Staff Data Requests

J. Zanesville Energy, LLC, Case No. 14-2254-EL-REN

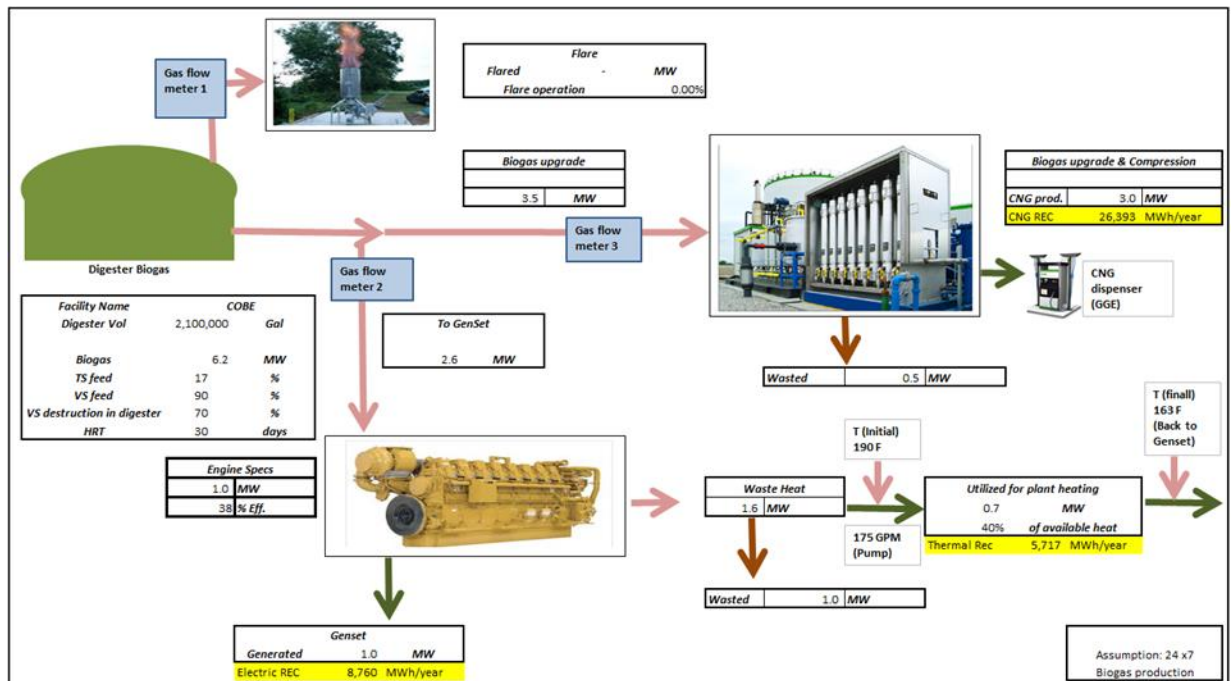
12. Regarding Section G.3 of the application, please provide a detailed description of how heat captured by each source is going to be measured and verified, including the configuration of the meter(s), the meter types(s), and meter accuracy. What is the projected in-service date of the thermal meters? Please provide documentation.
Thermal REC: Engine is cooled using a heat loop which circulates Glycol-Water mixture (50%) across the plant. The flow of the glycol is **175 GPM** (Pump rating, see fig.).

We have temperature sensor located in the engine which show the temperature of glycol taking waste heat from the engine. **The temperature is typically around 190° F** (See fig. 1) This glycol flows in the plant supplying heat for plant purpose (Digester heating, Floor heating, Pasteurization). **The return temperature of glycol is around 163° F** (See fig. 1)

$$\text{Heat utilized in the plant } \frac{\text{BTU}}{\text{min}} = 1,460 \frac{\text{lbs}}{\text{min}} * (190 \text{ F} - 163 \text{ F})$$

$$\text{Heat utilized in the plant } \frac{\text{BTU}}{\text{min}} = 39,808 \text{ BTU/min}$$

$$\text{Heat utilized in the plant } \frac{\text{BTU}}{\text{hr}} = 39,808 \frac{\text{BTU}}{\text{min}} * 60 \frac{\text{min}}{\text{hr}}$$

$$\text{Heat utilized in the plant } \frac{BTU}{hr} = 2,388,499 \frac{BTU}{hr}$$
